HISTORIC AND DESIGN REVIEW COMMISSION

October 05, 2022

HDRC CASE NO: 2022-494
ADDRESS: 620 LABOR ST
LEGAL DESCRIPTION: NCB 2957 BLK 1 LOT 27 ODINA PARK SUBD
ZONING: C-1 CD, H
CITY COUNCIL DIST.: 1
DISTRICT: Lavaca Historic District
APPLICANT: Evan Morris
OWNER: Scott & Elizabeth Kleberg/KLEBERG SCOTT M JR &
TYPE OF WORK: Exterior modifications, fenestration modifications, construction of a rooftop addition
APPLICATION RECEIVED: September 21, 2022
60-DAY REVIEW: Not applicable due to City Council Emergency Orders
CASE MANAGER: Edward Hall

1 SITE PLAN - PROPOSED
 SCALE: 1/8" = 1'-0"

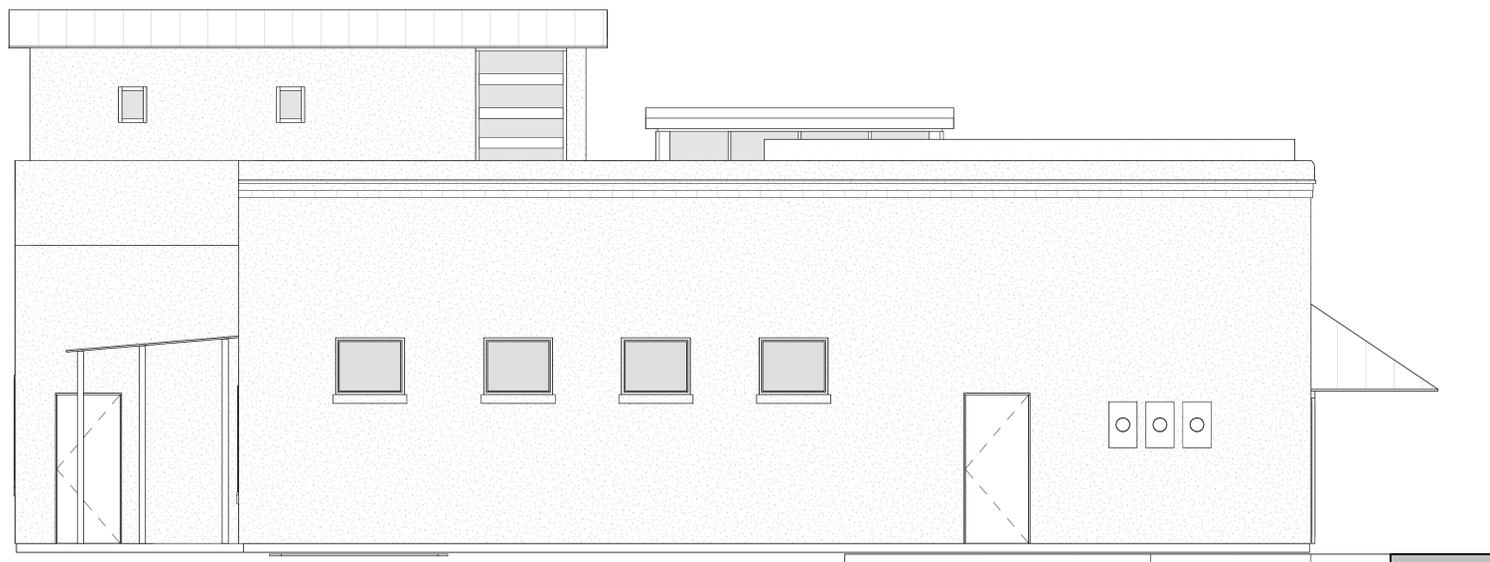
- i. FENCING – The applicant has proposed to replace the existing, front yard fencing. The existing fencing features multiple fencing profiles and materials. Staff finds that replacement with fencing to be consistent with the Guidelines to be appropriate. The applicant should submit a final fencing detail to be review and approved by OHP staff.

- j. REAR WALL – The applicant has proposed to construct a CMU wall with a stucco finish on the rear (east) property line to feature six (6) feet in height. The proposed fencing will be reduced to three (3) feet in height in the side yard along the east property line. The Guidelines for Site Elements 2.B. notes that new fences and walls should appear similar to those used historically within the district in terms of their scale, transparency and character. The design of fences and walls should respond to the design of the historic structure on the lot. Additionally, the Guidelines note that fences and walls should be installed in located where they have historically existed. Staff finds the installation of fencing of less than four feet in height along the east property line to be appropriate; however, staff does not find the installation of a solid wall in this location to be consistent with the Guidelines.

6. Staff recommends approval of item #6, the installation of site walls and fencing, based on findings i and j with the following stipulations:
- i. That the proposed front yard fencing (along the west, north and south property lines) not exceed four (4) feet in height, be transparent and feature materials and a profile consistent with fencing found traditionally in the district.

- ii. That the proposed rear wall transition to a fence not to exceed four (4) feet in height at the south façade of the structure on site. The proposed fencing should be transparent and feature materials and a profile consistent with fencing found traditionally in the district.

1 PROPOSED EAST
 SCALE: 1/4" = 1'-0"

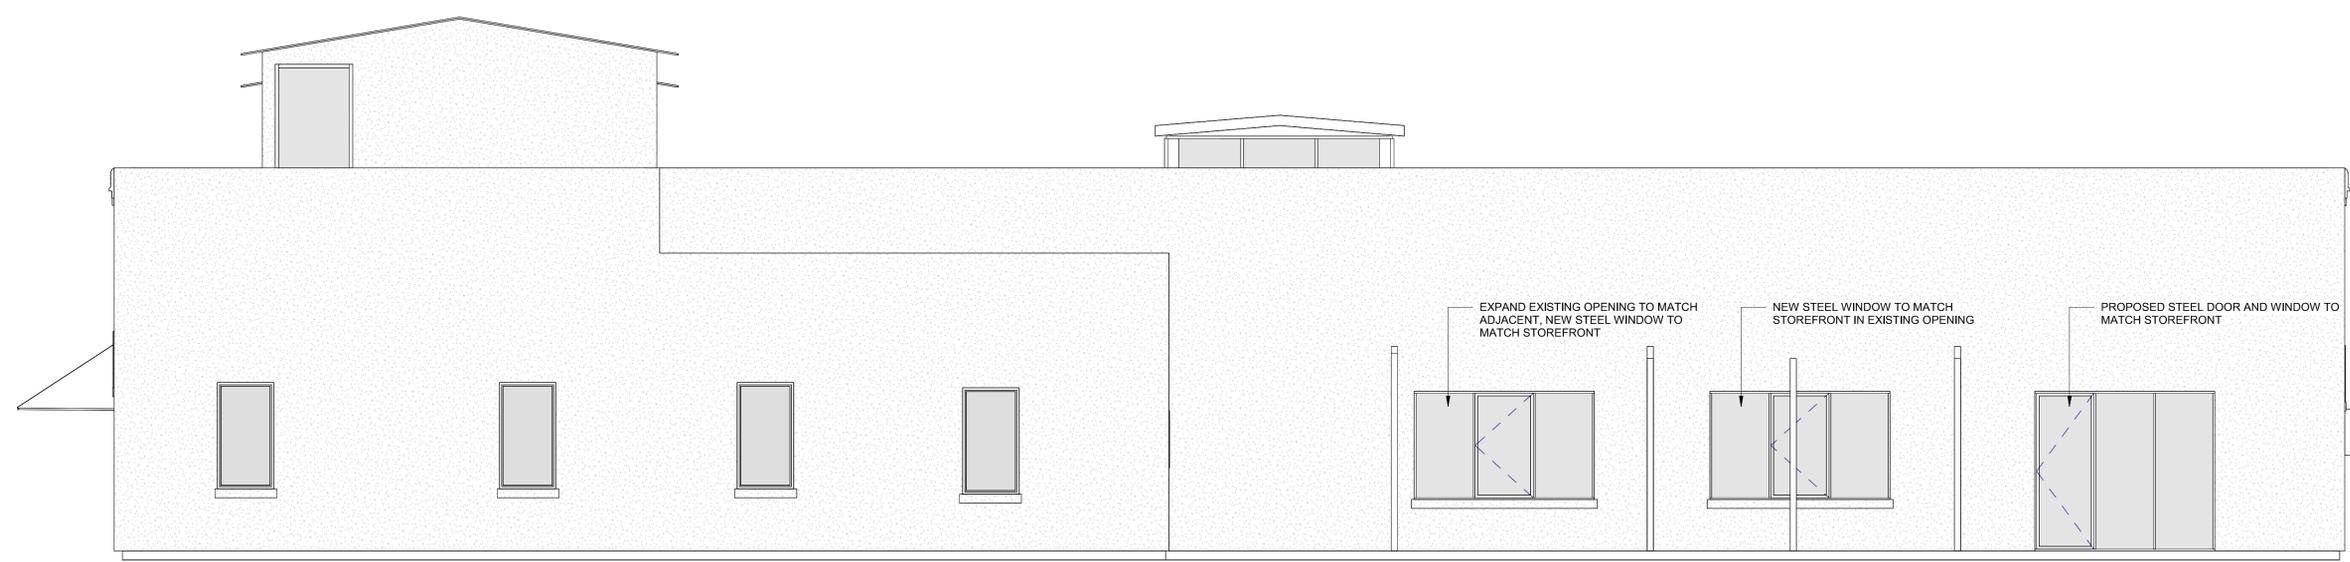
- f. EAST (REAR) FAÇADE – The applicant has proposed to perform modifications to the east, rear façade that include the removal of a north facing door opening, and the removal of two existing window openings and one door opening. The applicant has proposed to install two new window openings and one new door opening in their place. Given the location of these openings on the rear façade, staff finds their modification to be appropriate; however, staff finds that contemporary storefront systems that do not complement those of the historic structure are not appropriate and are not consistent with the Guidelines.

- iii. That the applicant present alternative materials in place of the proposed metal wire mesh.
4. Staff recommends approval of item #4, modifications to the rear (east) façade based on finding f with the following stipulations:

- i. That the applicant install entrance and storefront elements that features a profile and appearance consistent with those found historically on the structure.

2 PROPOSED - WEST
 SCALE: 1/4" = 1'-0"

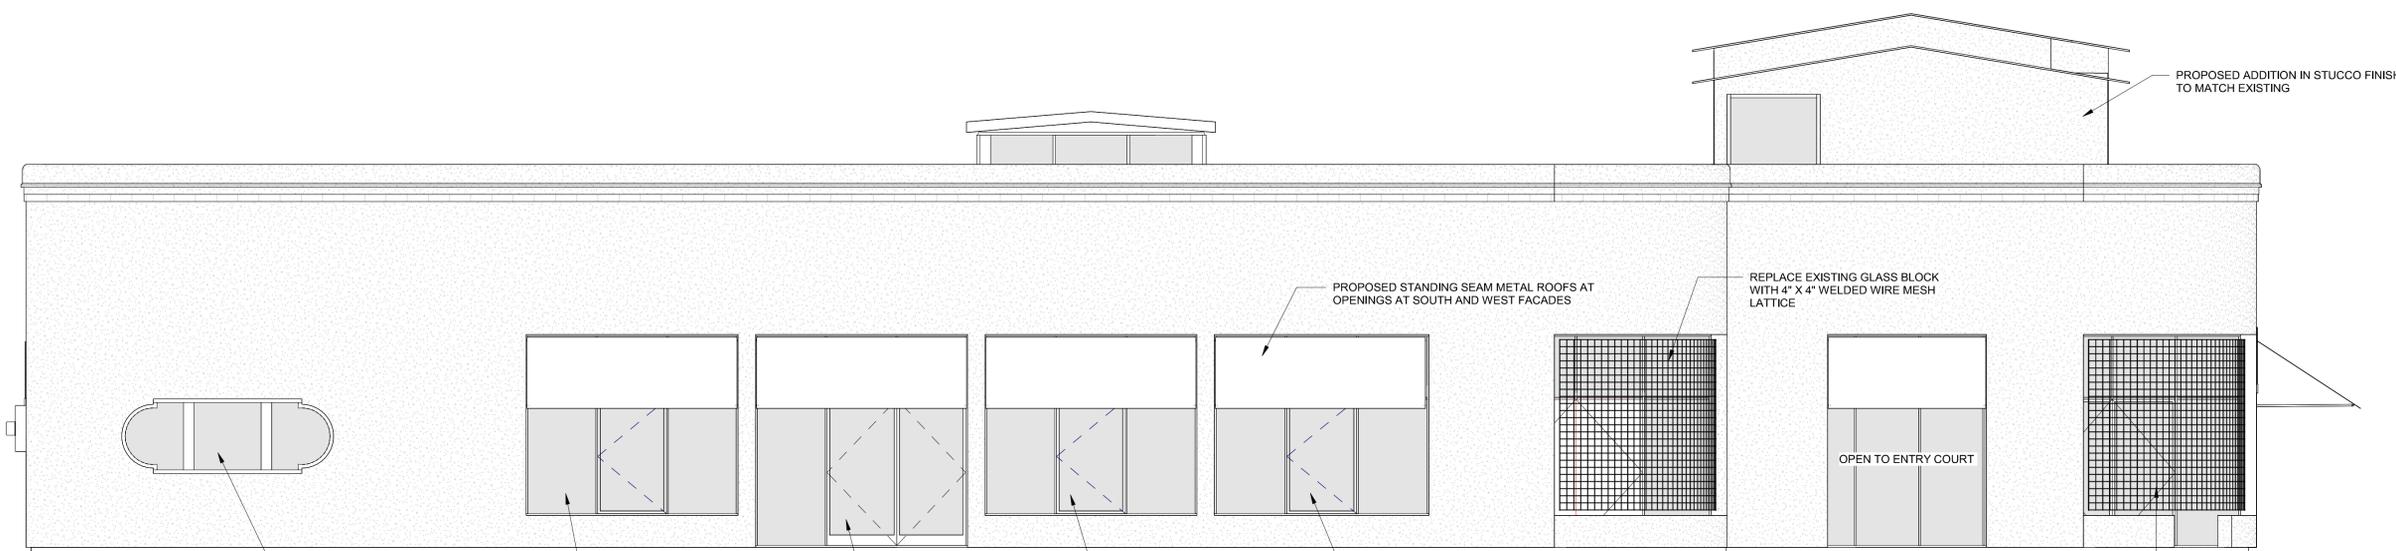
- d. **WEST (FRONT) FAÇADE** – The applicant has proposed to perform modifications to the front (west) façade to include modifying the existing, non-original storefront system openings and creating new, contemporarily sized opening in the locations of historic openings; replacing the existing, non-original glass block, with wire mesh lattice; installing a new storefront system in the existing double width opening; and the removal of a non-original awning and installation of new awnings. The proposed new storefront windows will not be re-installed

in a profile that is consistent with the original. Staff finds that the original window openings should be re-introduced to be consistent with the Guidelines. Additionally, staff finds that the front canopy profile and installation location should match that original installed on the front façade. Staff finds the removal of the non-original glass block to be appropriate; however, staff finds that architecturally appropriate entrance should be installed. A contemporary storefront system that does not feature a profile and materials that are consistent with the original structure is not consistent with the Guidelines.

2. Staff recommends approval of item #2, modifications to the front (west) façade based on finding d with the following stipulations:
 - i. That the storefront modifications be based on historic and existing evidence and that the new fenestrations match historic configurations and profiles including the extant transom windows.

- ii. That a replacement canopy be installed to match the profile and location of the original canopy.
 - iii. That the applicant propose a traditionally profiled entrance door within the existing addition on the front façade that features a profile and appearance consistent with those found historically on the structure.
